**SECTION 75W MODIFICATION
APPLICATION
CIVIL WORKS STAGE 1 AT POTTS
HILL RESERVOIRS, POTTS HILL**

MP 08_0069 (MOD 3)

Modification of Minister's Approval under section 75W
of the *Environmental Planning and Assessment Act*
1979

July 2010

Figure 2 – Proposed amended subdivision plan

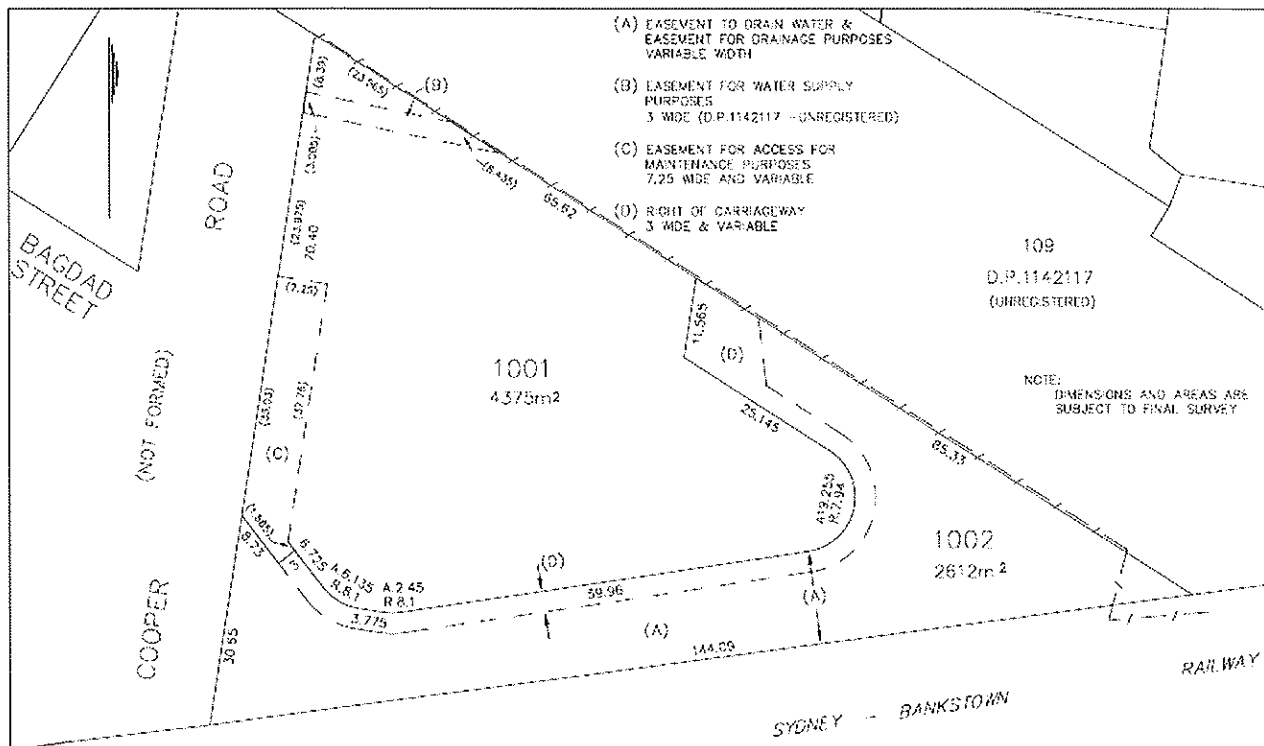
The approved subdivision plans for the Potts Hill Reservoirs Site show the Bagdad Street site forming Lot 108. The proposal involves the subdivision of this site into two lots, to be known as Lot 1001 and 1002, as illustrated in **Figure 2**. Proposed Lot 1001 is to accommodate a future ADHC development. Lot 1002 is to be dedicated to Council as a drainage reserve.

The proposed re-subdivision of the subject site does not affect the staging plan for the overall Potts Hill lands. Accordingly, it is recommended the Conditions of Approval to MP 08_0069 be modified to include new subdivision plans creating the two lots on the Bagdad Street site.
